**MS-06 CHANNEL IMPROVEMENTS - TYPICAL SECTION**

SADDLEHORN RANCH - FILING 3 CHANNEL IMPROVEMENT PLANS

SHEET 48 OF 64  
JOB NO. 25142.05

**CUTOFF WALL 3 PROFILE  
STA 1+00.00 TO 1+90.22**

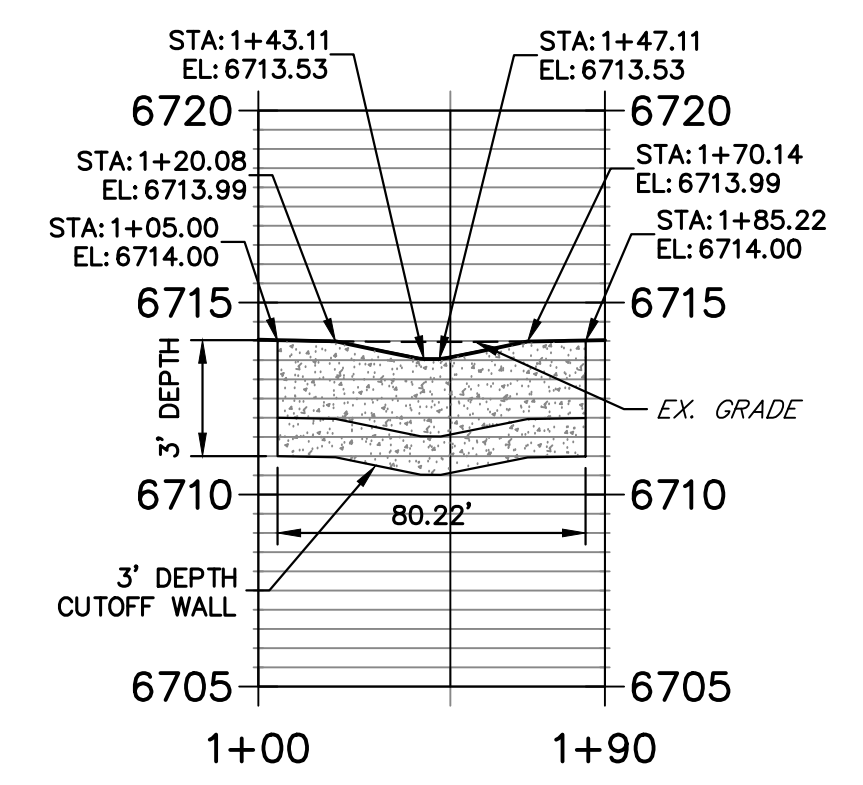
Consider adding a cutoff wall at the full graded width (see FDR sheet)

**JR Response: Cutoff walls have been added to this section along the full graded width.**
